SIR FREDERICK MESSER ESTATE

NMA SECTION 96 APPLICATION

REVISION: P06

DATE: June 2026

SECTION 2 Site Location Plan

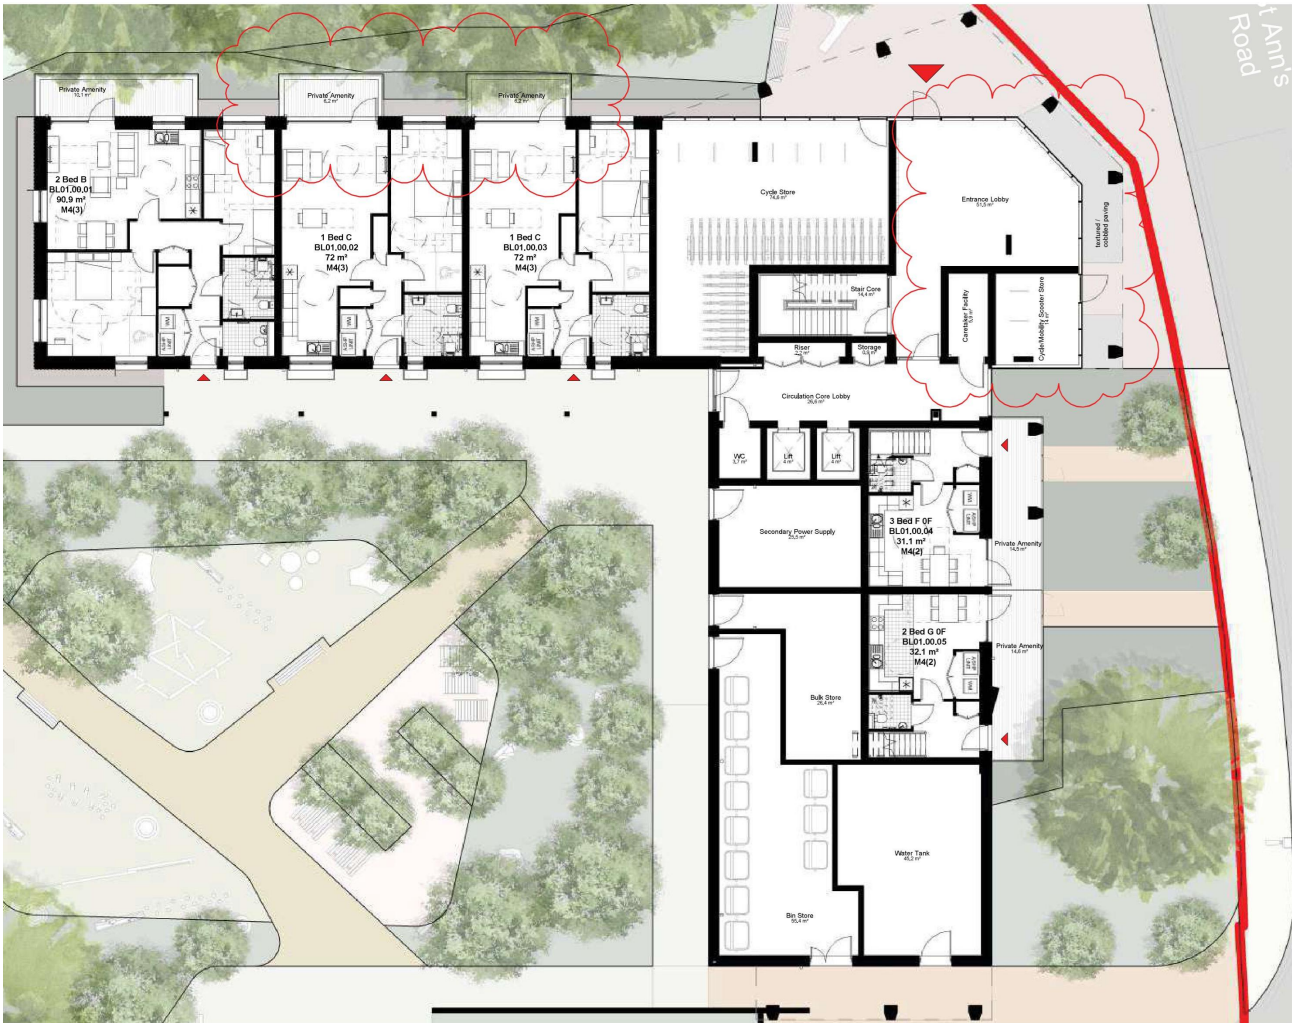
2. Block 1 relocated and moved 2 metres towards Block 2 (dashed purple line indicates previous building location).

SECTION 2 Block 01_Ground Floor Plan

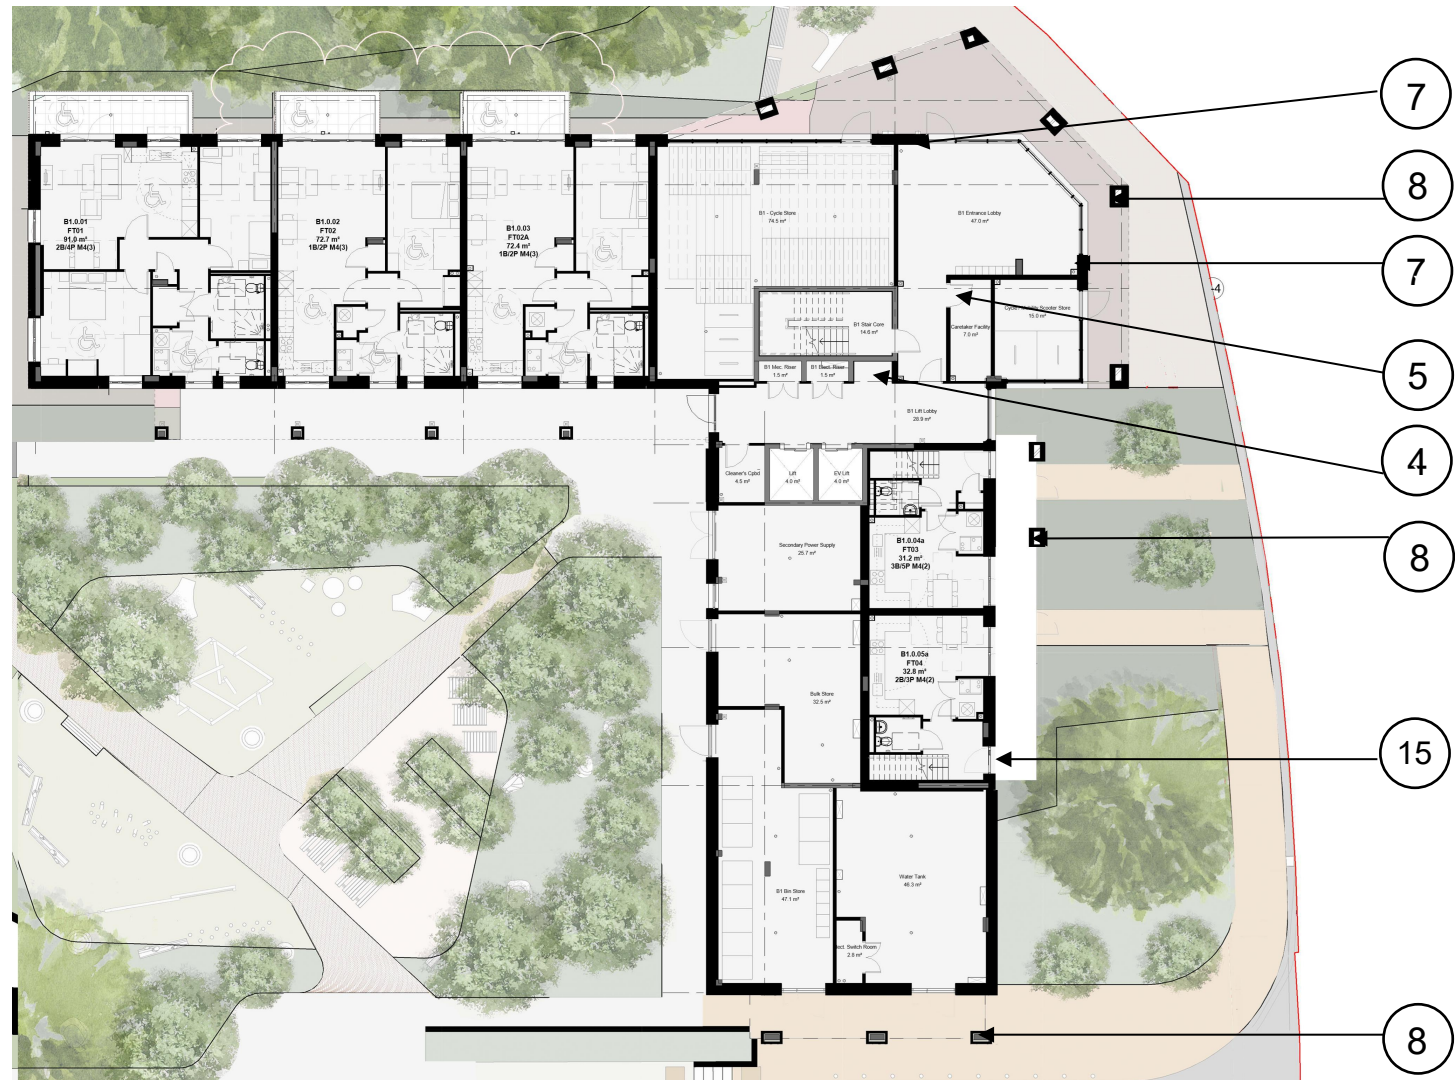
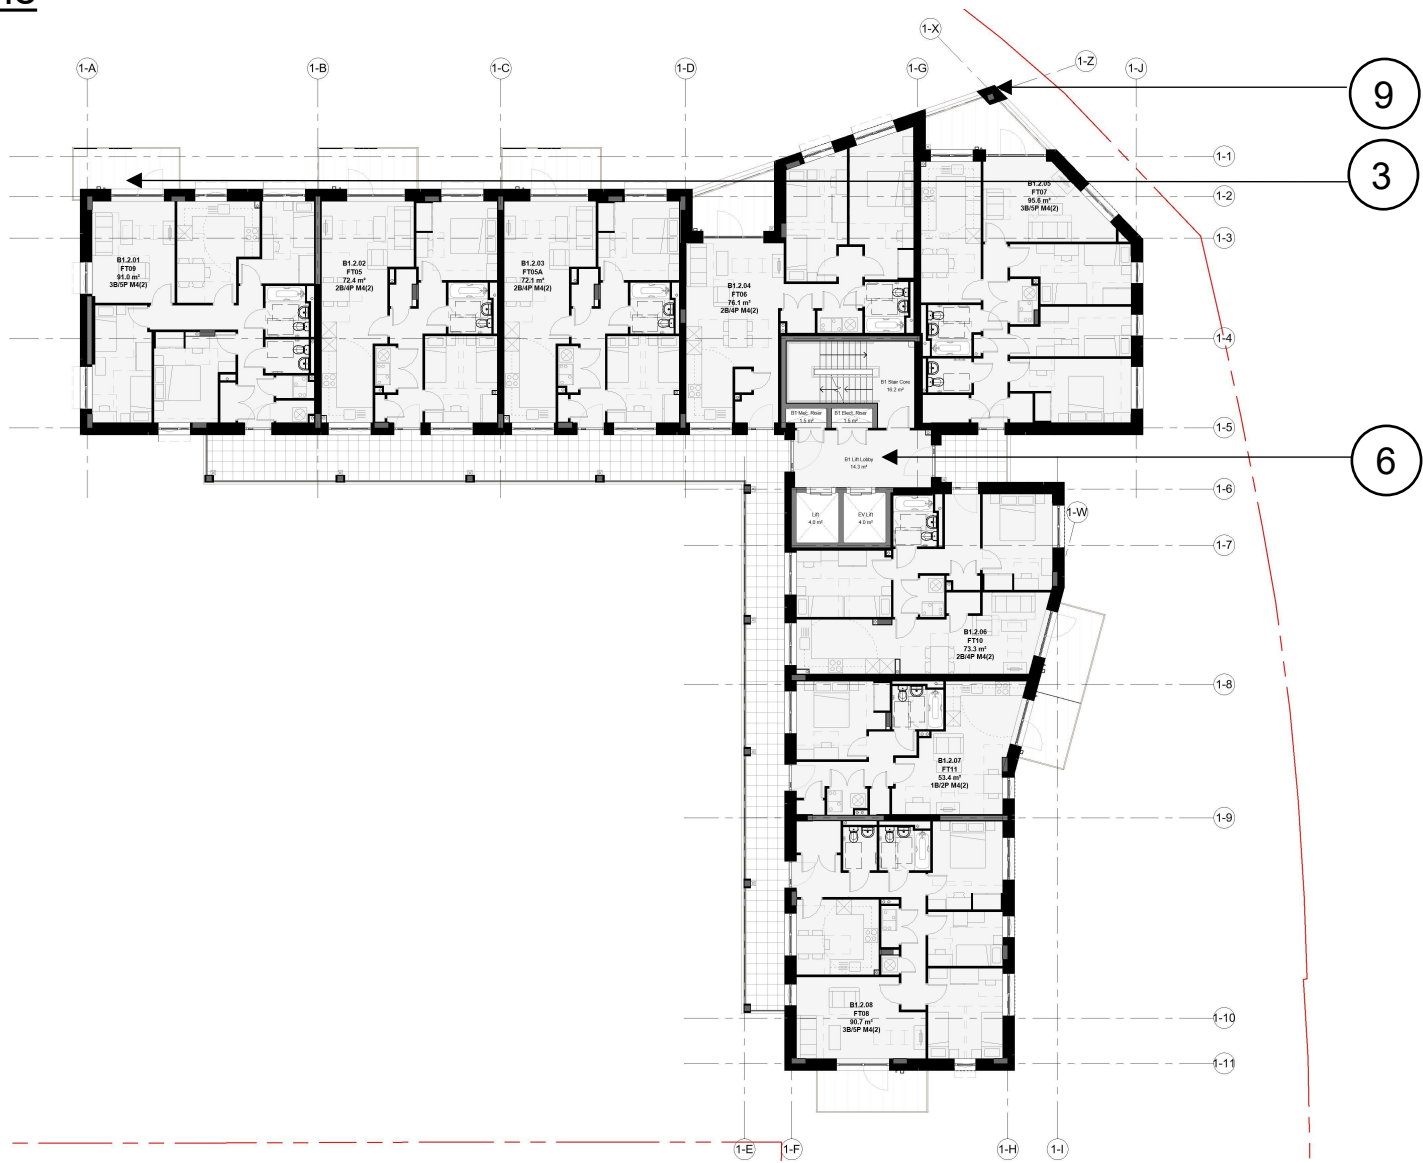
- 4. Lift lobby storage removed.
- 5. Caretaker facility room door relocated.
- 7. Main entrance brick pier for panelling and services installation.
- 8. Ground floor external columns clad in brickwork to match building.
- 15. Canopy over entrance door added.

SECTION 2 Block 01_Roof Plan

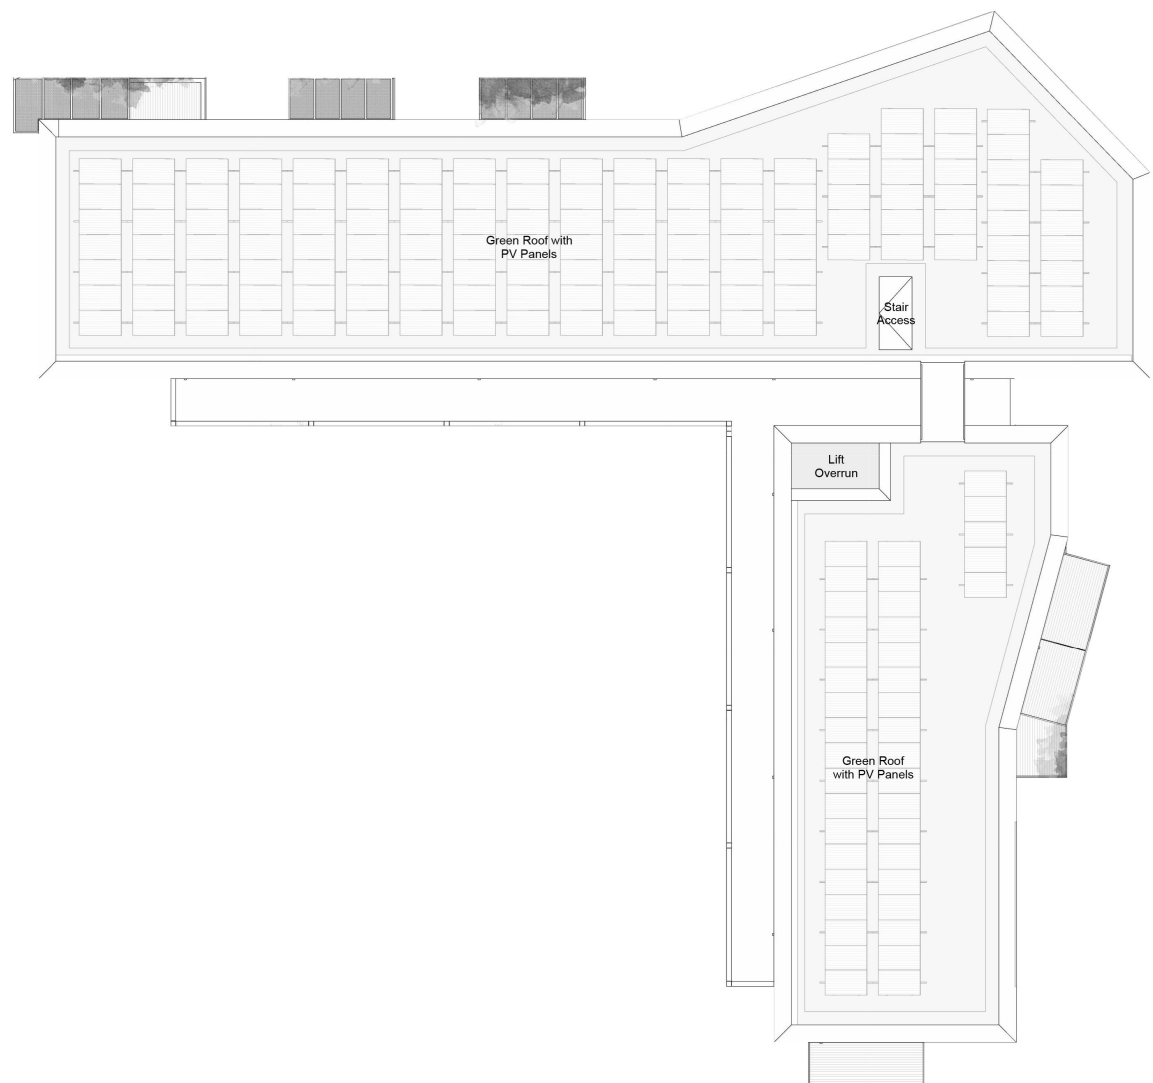
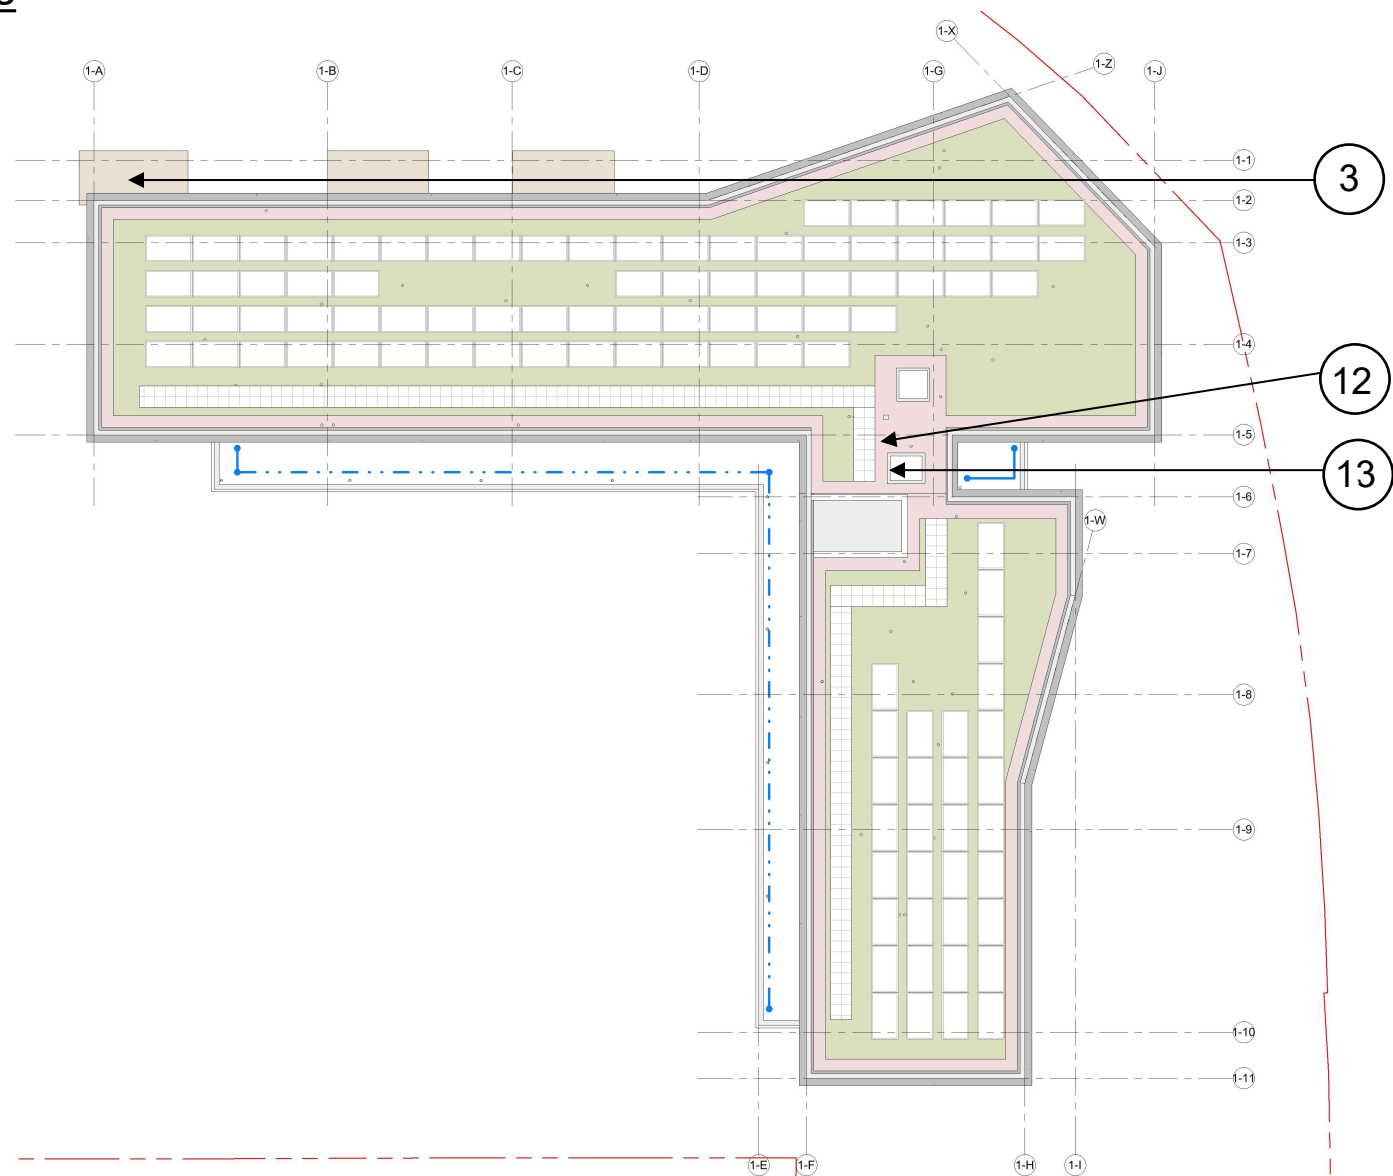
- 3. Corner bolt-on balconies cantilevered reduction.
- 12. Bridge to connect both building wings.
- 13. Roof AOVs on top of stair core and lift lobby added.

SECTION 2 Block 02_Ground Floor Plan

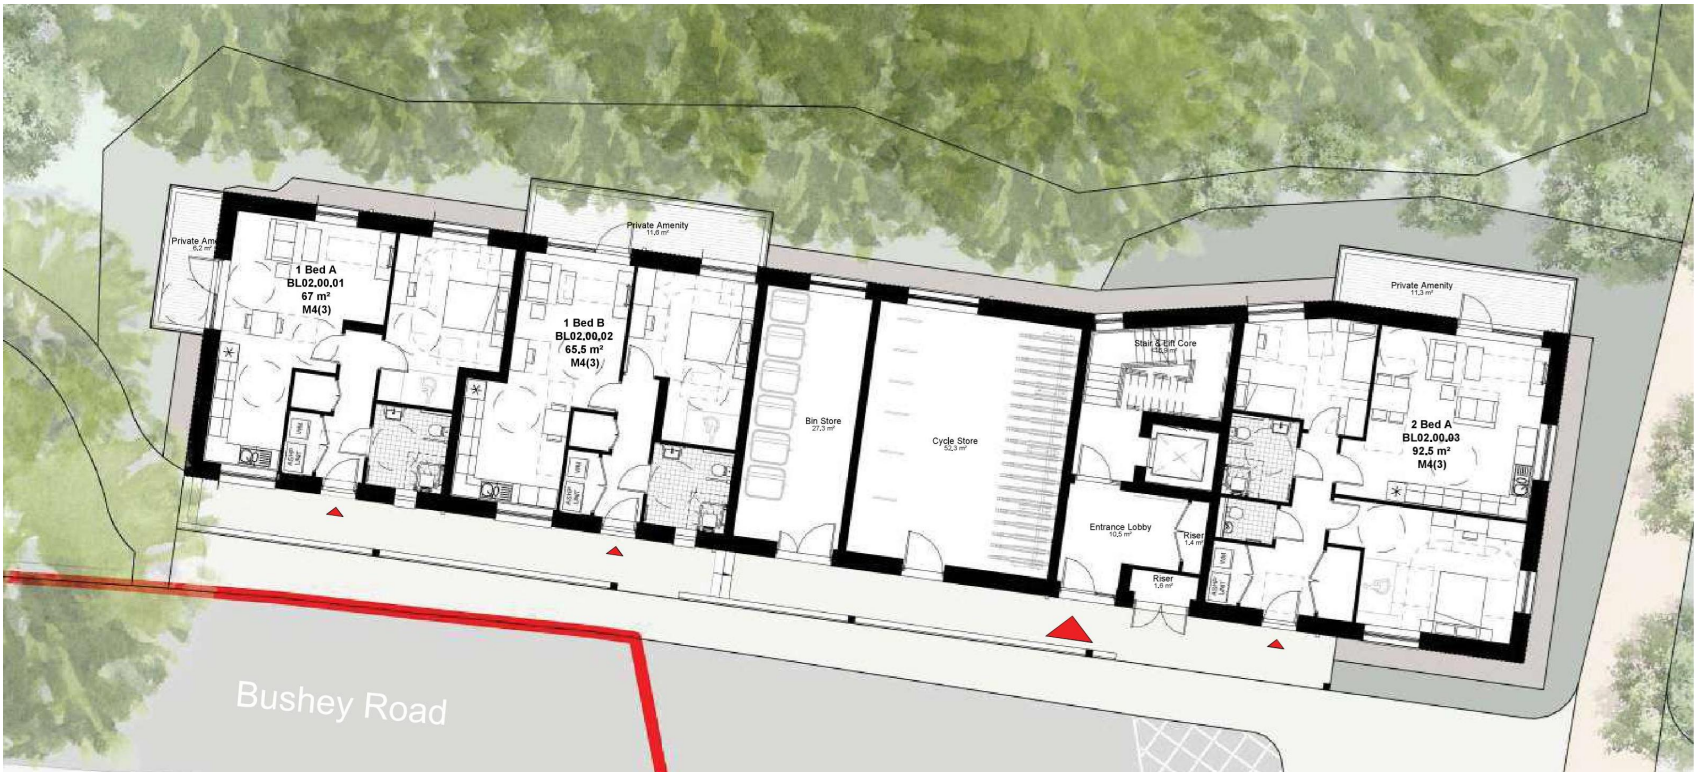
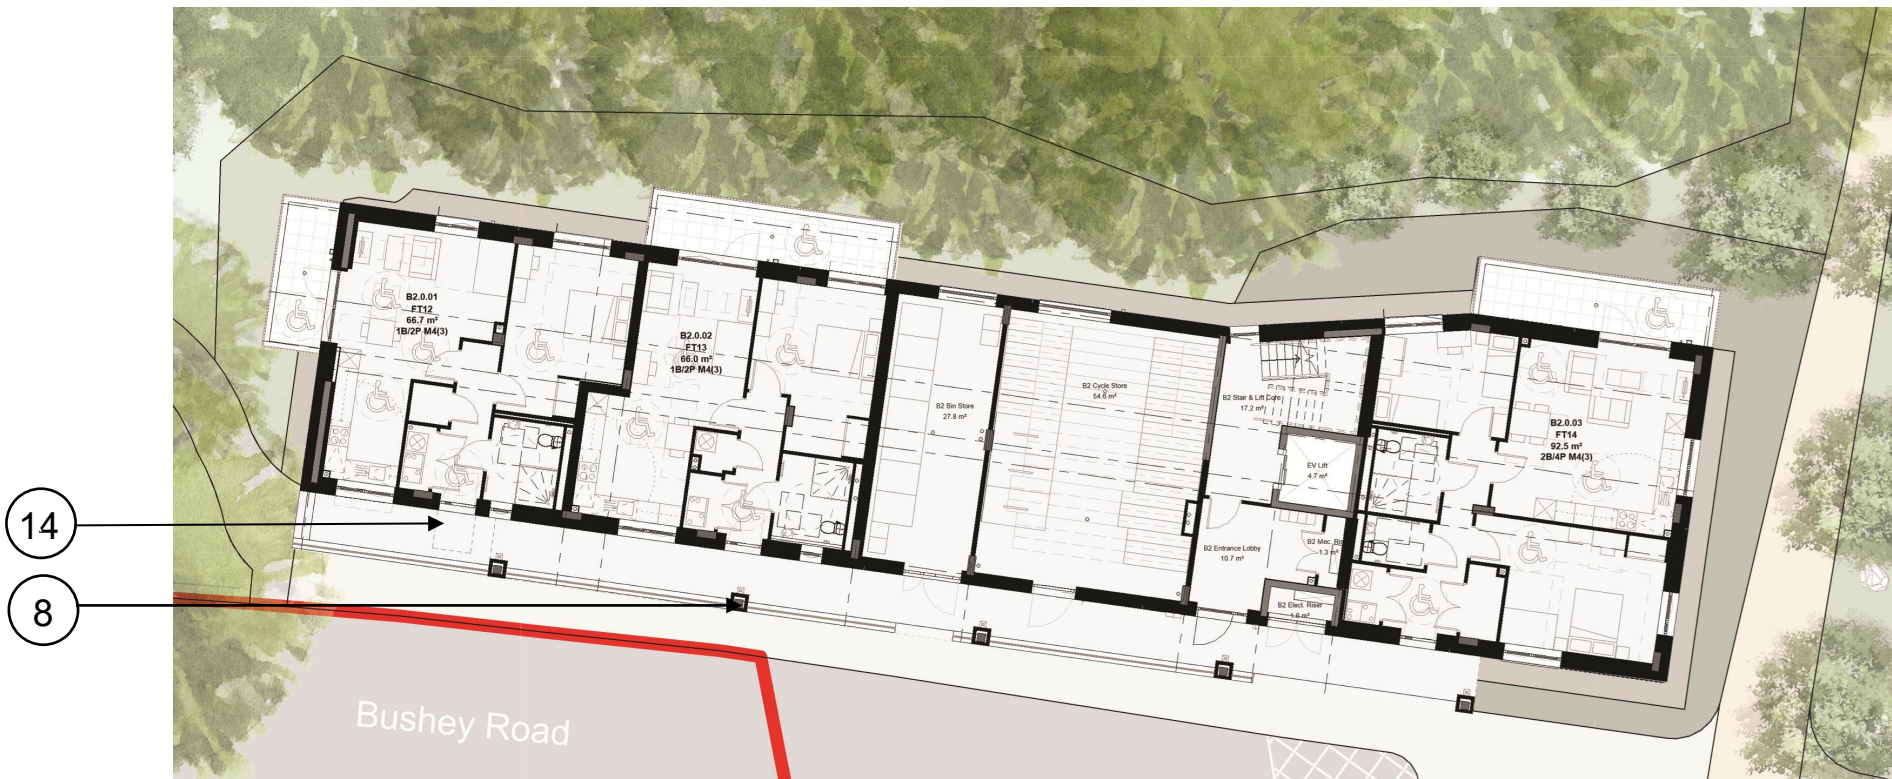
- 8. Ground floor external columns clad in Ibiza white brickwork.
- 14. Canopy over entrance door added.
